## Product Change Notification(PCN)

### V5616x-T 35x17x13mm Stamping heatsinks black anodized

**Change Notification:** PCN 20190404 V5616x-T

**Description of changes:** Change of production plant  
1. Change of tolerance  
2. Draw.-No. ASS\_0488\_HSrev03 substitutes ASS\_0488\_HSrev02

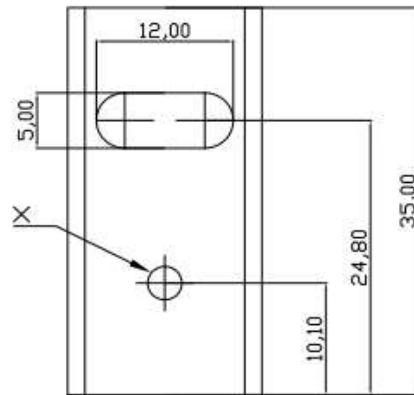
V5616x-T	Old version	V5616x-T	New version																																				
1. Change of tolerance:		1. Change of tolerance:																																					
<table border="1"> <tr><td>Scale</td><td>1:1</td></tr> <tr><td colspan="2">TOLERANCE</td></tr> <tr><td>X.</td><td>±X</td></tr> <tr><td>X.X</td><td>±X</td></tr> <tr><td>X.XX</td><td>±X</td></tr> <tr><td>DIM</td><td>TOL</td></tr> <tr><td>X.°</td><td>±X°</td></tr> <tr><td>X.X°</td><td>±X°</td></tr> <tr><td>Angle</td><td>TOL</td></tr> </table>		Scale	1:1	TOLERANCE		X.	±X	X.X	±X	X.XX	±X	DIM	TOL	X.°	±X°	X.X°	±X°	Angle	TOL	<table border="1"> <tr><td>Scale</td><td>Free</td></tr> <tr><td>③ TOLERANCE</td><td></td></tr> <tr><td>0-6</td><td>±0.10</td></tr> <tr><td>6-30</td><td>±0.20</td></tr> <tr><td>30-120</td><td>±0.30</td></tr> <tr><td>120-400</td><td>±0.50</td></tr> <tr><td>DIM</td><td>TOL</td></tr> <tr><td></td><td></td></tr> <tr><td>Angle</td><td>±0.5°</td></tr> </table>		Scale	Free	③ TOLERANCE		0-6	±0.10	6-30	±0.20	30-120	±0.30	120-400	±0.50	DIM	TOL			Angle	±0.5°

Scale	1:1																																						
TOLERANCE																																							
X.	±X																																						
X.X	±X																																						
X.XX	±X																																						
DIM	TOL																																						
X.°	±X°																																						
X.X°	±X°																																						
Angle	TOL																																						
Scale	Free																																						
③ TOLERANCE																																							
0-6	±0.10																																						
6-30	±0.20																																						
30-120	±0.30																																						
120-400	±0.50																																						
DIM	TOL																																						
Angle	±0.5°																																						
For detail, please take attached new drawing for reference: ASS_0488_HSrev03
